Access Compliance Report
Public Rights-of-Way
(Curb Ramps)

Main Street: UNIVERSITY_AVE | **Cross Street:** CREIGHTON_DR | **Location:** S

ADA ID: RPRK211026140937 | **Ramp Type:** Type 1 - Perpendicular | **Initial Pass/Fail:** Pass | **Overall Compliance:** No | **Severity Score:** 16

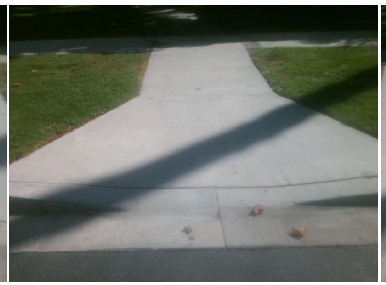
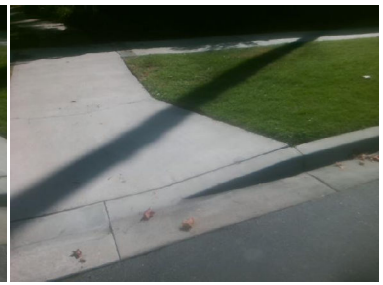
Install Detectable Warning System. Remove & Replace Gutter.
